# MODIFICATION RECOMMENDED

## U9401B-01

# S E R V I C E N O T E

U9401B - i1000D systems

Figure 2.0

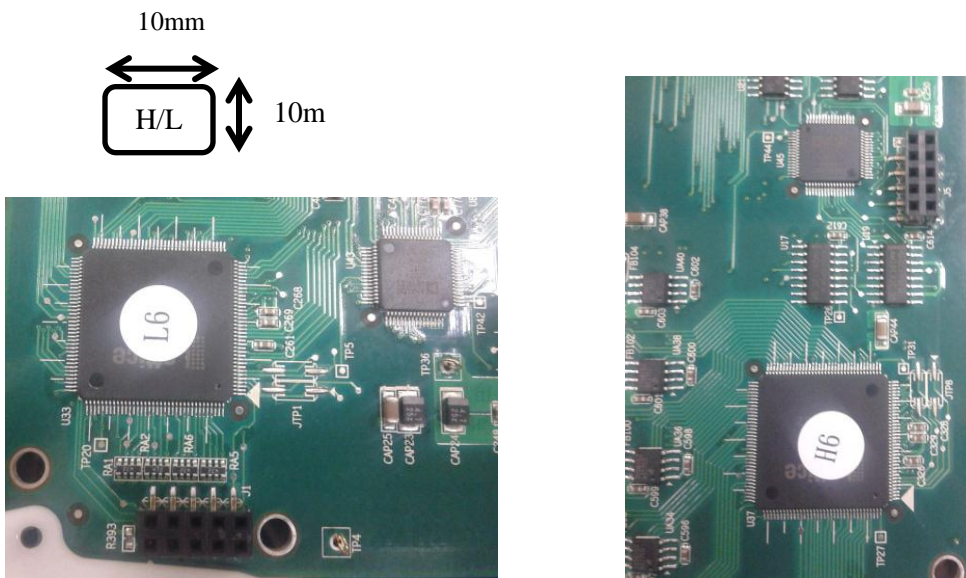
2. On top of the Lattice XP IC label, request to change from H6 & L6 to H7 & L7 as Figure 2.0

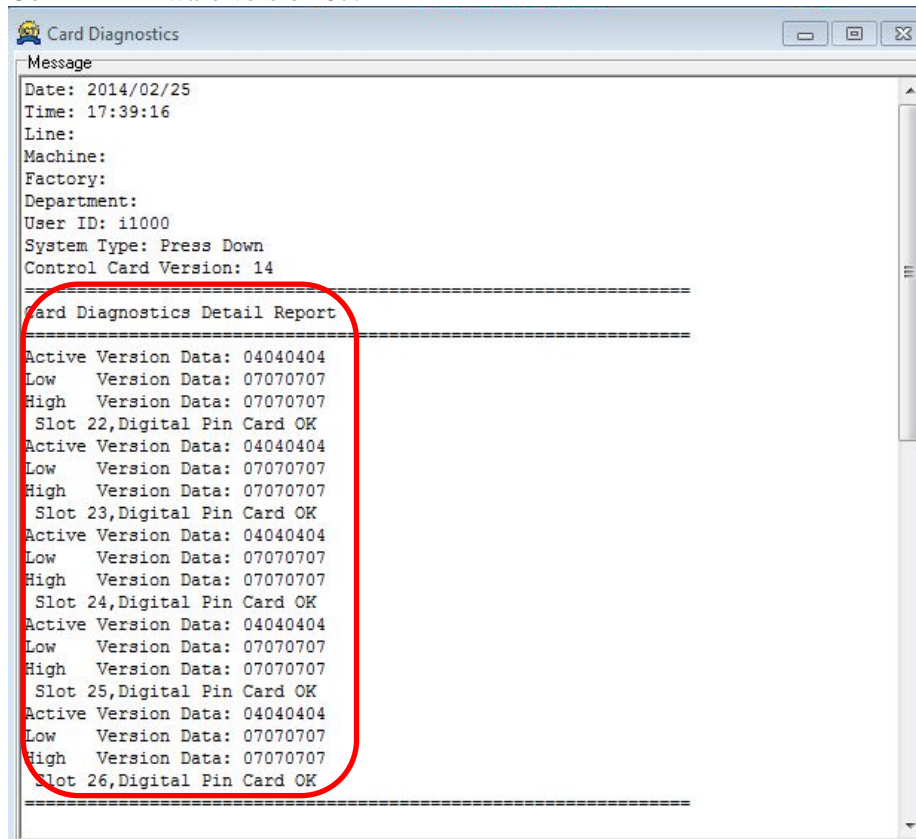
### 2. Confirm firmware version 07.

Low = “07|07 |07|07” to represent the 4xLow Channel IC Firmware  
 High = “07|07 |07|07” to represent the 4xHigh Channel IC Firmware
